**Re: Initial Submission Review – 63rd and Kirk LLC Multi-Family at Painted Prairie  
Site Plan with Adjustment**  
Application Number: **DA 1556 29**  
Case Numbers: **2022 4056 00**

## *First Submission Review*

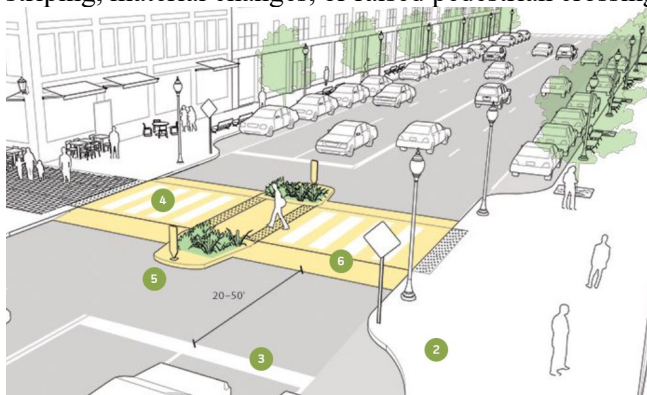
- 5A. The parking garage follows the correct 90-degree code requirements of 19x9. These dimensions are only necessary for the required 461 parking spaces. Any parking spaces beyond 461 could be moved to compact parking or large parking stalls.
